Neher Sales SP10-43

PROJECT NEHER SALES SITE PLAN 10-43

Public hearing at the request of RHO Real Estate, Inc., for Preliminary Site Plan, Wetland Permit, Woodland Permit and Storm Water Management Plan approval. The subject property is located in Section 14 at 41700 Eleven Mile Road on the north side of Eleven Mile Road between Delwal Drive and Meadowbrook Road in the I-1, Light Industrial District. The subject property is 3.98 acres and the applicant is proposing a 9,296 sq. ft. two story general office building.

Figure 1. Approximate site location: north side of 11-Mile west of Meadowbrook Rd.

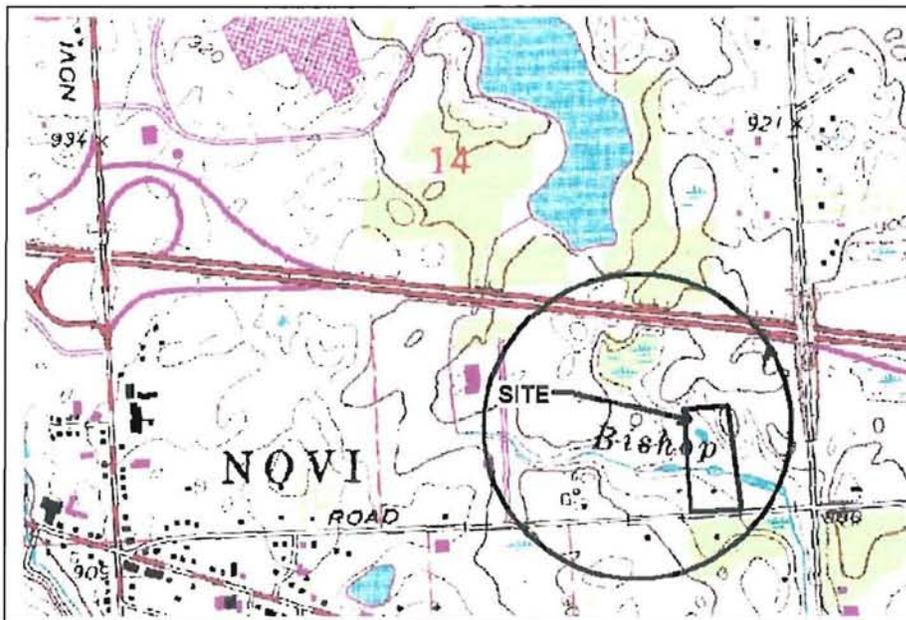
The Neher site is located in a portion of the SE quarter of Section 14, on the north side of 11-Mile Road between Novi and Meadowbrook Roads. The site appears to be inactive at this time with a brick one-story house near 11-Mile Road, and a small barn near the north end. Bishop Creek and Bassett Drain flow through the property (Figure 1).

Neher Holdings Site, 41700 W. 11 Mile Road

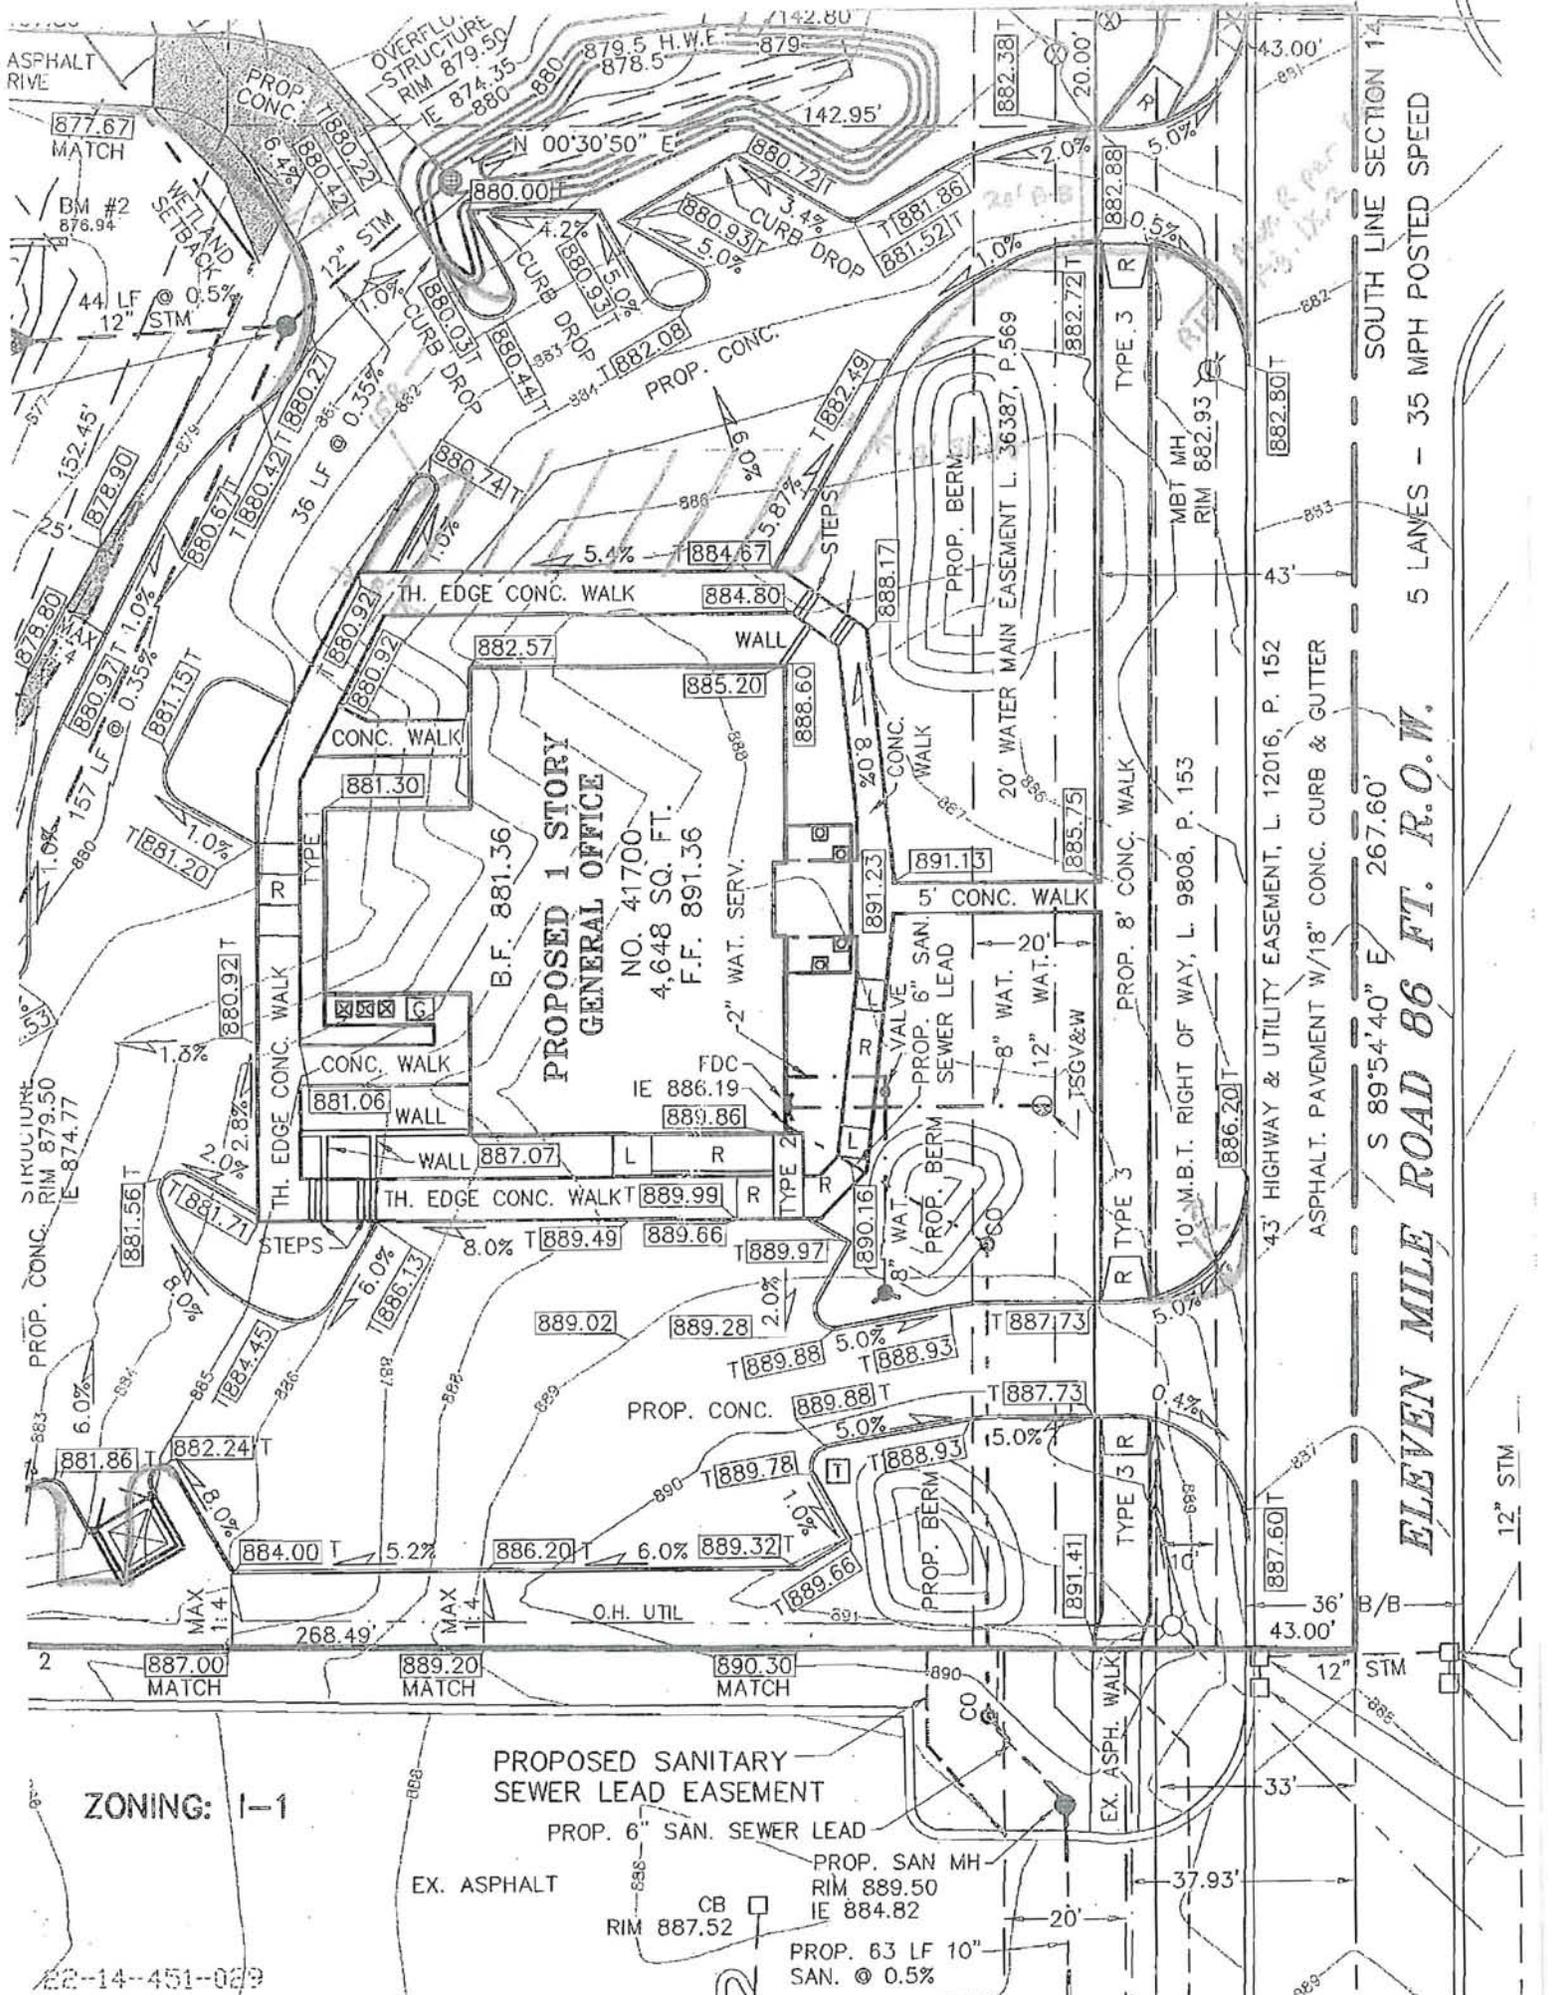
7. Given the lane configuration on 11 Mile Road and the importance of accommodating the City's largest fire truck, we recommend the driveway design revisions shown in the attached plan mark-up. In summary:

9. The site design near the northeast corner of the proposed building is too constricted to permit necessary movements by large trucks. Specifically, the driver of a large fire truck or other large vehicle would find it very difficult to turn into the secondary driveway to the north without jumping the curb adjacent to the bio-retention area, and the driver of a large single-unit delivery truck would find it very difficult to enter and exit the designated loading area without jumping the curb of the proposed adjacent 4-ft wide end island. **Our proposed redesign, shown in the attached plan mark-up, would require shifting the angled parking spaces along the east side of the building 4 ft to the south, and providing larger (minimum 15-ft) radii on the two end islands generally east of the loading area.**
